**UNITED STATES
NUCLEAR REGULATORY COMMISSION
ADVISORY COMMITTEE ON REACTOR SAFEGUARDS
WASHINGTON, DC 20555 - 0001**

SUBJECT: CERTIFICATION OF THE MINUTES OF THE MEETING OF THE ACRS
 SUBCOMMITTEE ON DIGITAL INSTRUMENTATION AND CONTROL
 SYSTEMS, NOVEMBER 18-19, 2014—ROCKVILLE, MD

**ADVISORY COMMITTEE ON REACTOR SAFEGUARDS
MINUTES OF THE ACRS DI&C SUBCOMMITTEE SUBCOMITTEE MEETING
NOVEMBER 18-19, 2014**

Detailed Model for the Development Quality Node of the Design Phase – Figure 3

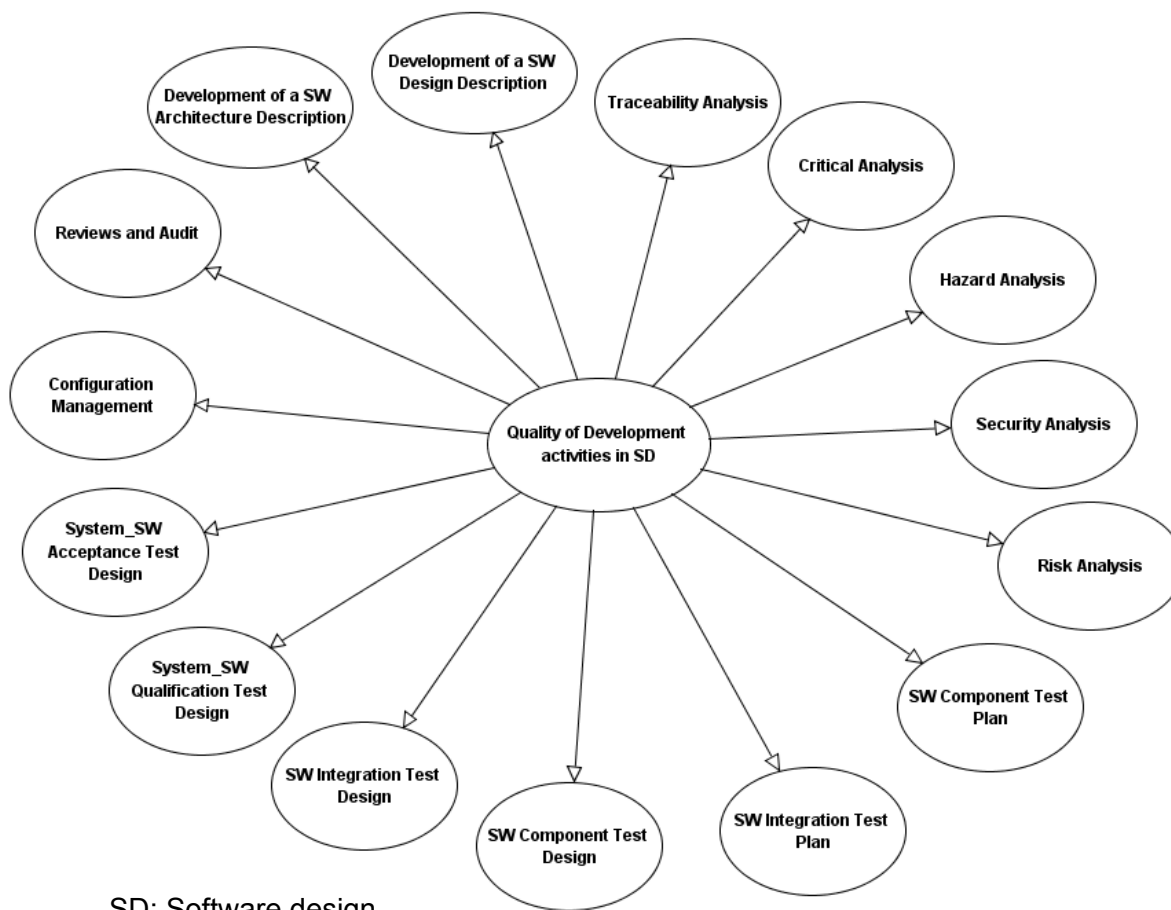
But the third bullet has to do with solving of the BBN model. We are using the AgenaRisk software tool. This is the software tool developed by Norm Fenton. Using this tool we have tested in that Figure 3 with all the attributes in a diverging configuration.

- Complexity of the model makes it difficult to solve. The large number of attributes makes it a challenge to use a converging configuration (computational demand due to state explosion) which is more consistent with the actual causal-relationship. A diverging configuration (Figure 3) is used instead.

EPRI 3002000509 Appendix B: Taxonomy of Failure Modes, Failure Mechanisms & Defensive Measures (cont.)

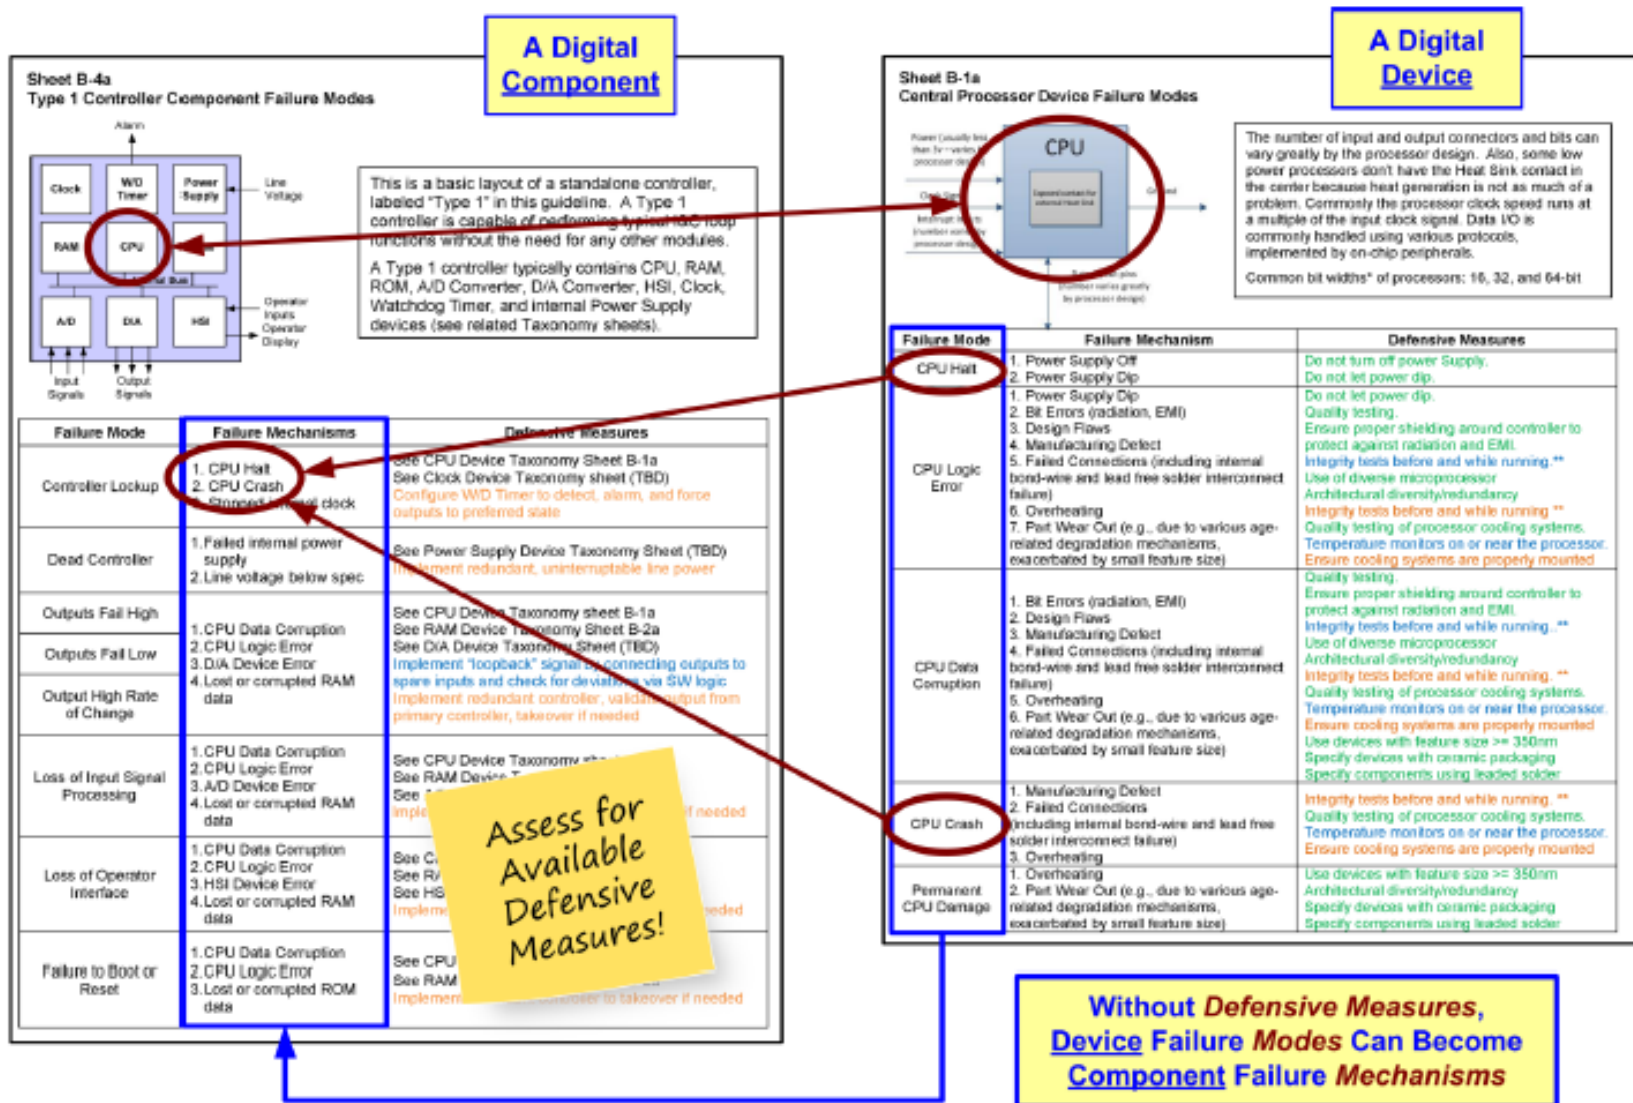
MR. HECHT: I guess in the defensive measures it says, see CPU device, taxonomy sheet B-1a and what does that say?

MR. GEDDES: Right. So if we have the digital component, which is Sheet B-4a, on the left hand side, we break that down to, what is a CPU? We have a short description of what a CPU is, or could be, and then how can it fail and what defensive measures might be available to, you know, limit or reduce the likelihood of those failure mechanisms?
